ADVISORY HOTLINE FIX

Group: 52 – Interior	**Original Date:** 01/05/2018	**No.** MQ52-003
Model: MQ Triton	**Subject:** Recovering air vent after locking knob or fins.	
Revised on: …….. **Revised on:** …….. **Revised on:** ……..	R. Versteeg National Service Manager Service Operations	
MMAL Ref TSL1704026	**Document consists of 3 pages**

1) **Subject**: Recovering air vent after locking knob or fins.

(1) Stuck the fin then broken the fin.

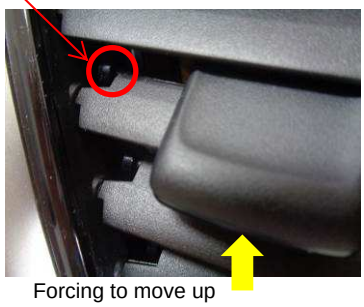
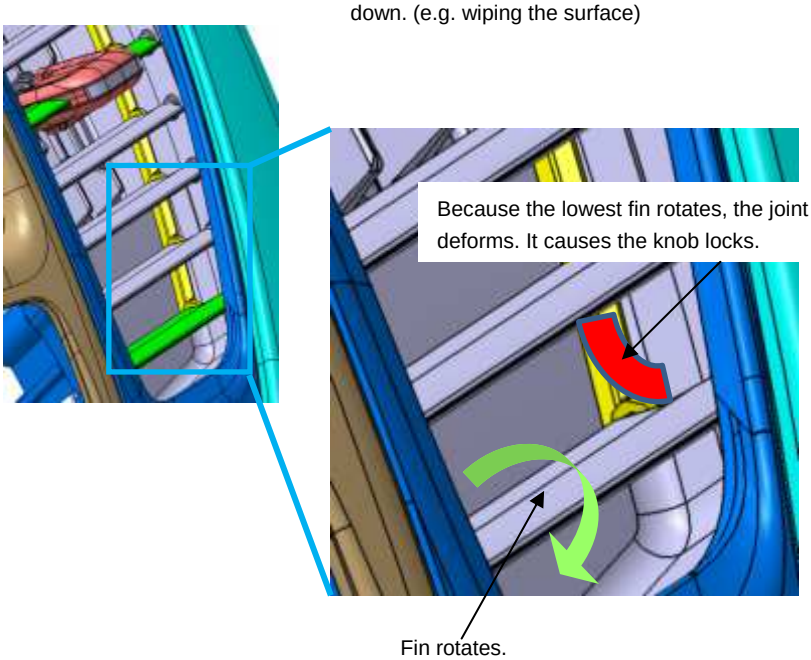
1. The lowest fin is pushed down. (e.g. wiping the surface)

2. The lowest fin rotates.

Center fin broken at axis

Forcing to move up

3. The knob locks. If it is forced to move up, the center fin is broken at the axis.

To recover the movement, push the upper edge of the lowest fin. The lowest fin comes back to the normal position.

(2) Stuck by air freshener

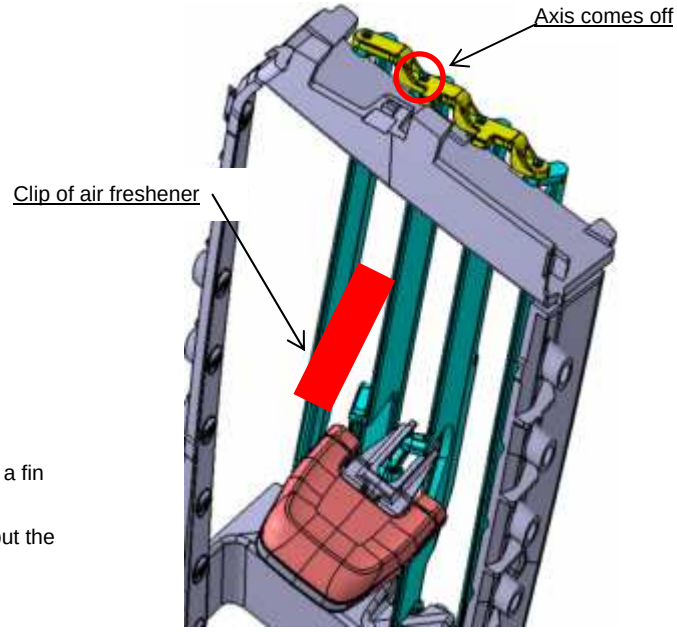
An air freshener lies on the air outlet.
It obstructs movement of fins.

A clip of an air freshener goes inside and stays between a fin and one another.
When a knob is moved left/right, the fin does not move but the joint tries to move.
The axis of the fin comes off from the joint.

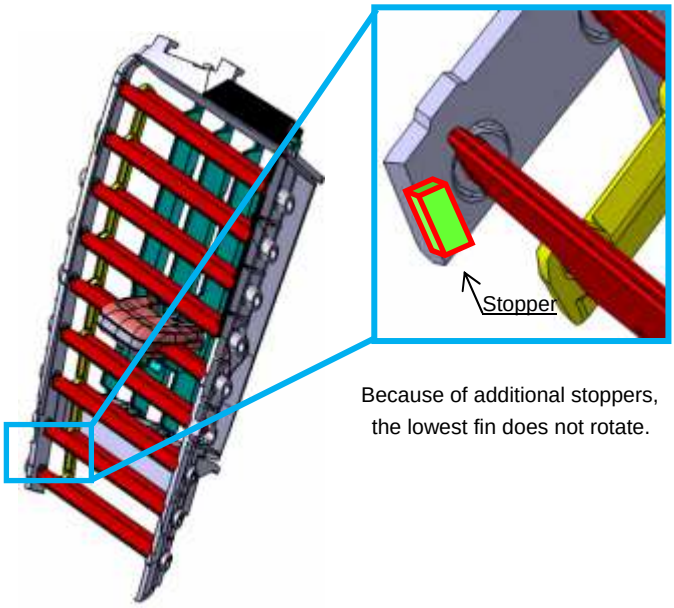
When the knob is up/down, fins do not move but the joint (yellow) tries to move.
The axis of the fin comes off from the joint.

2) Details of Production Fix and how to distinguish it

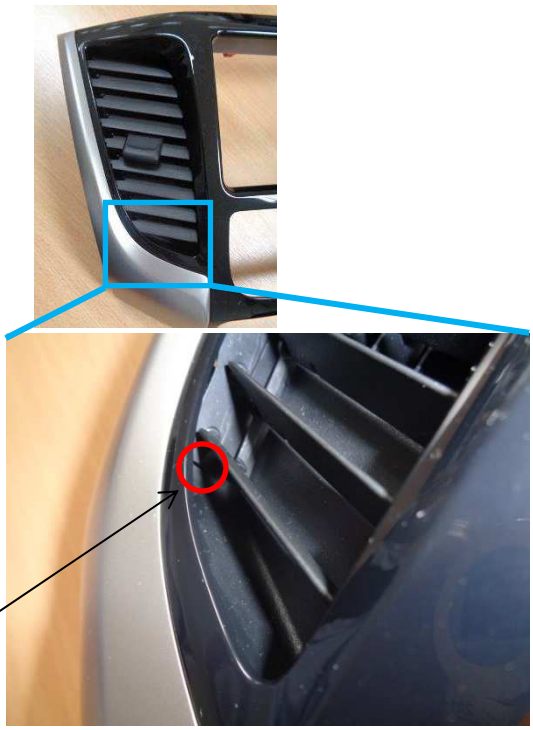
Because of additional stoppers,
the lowest fin does not rotate.

The stopper can be seen in the circle.
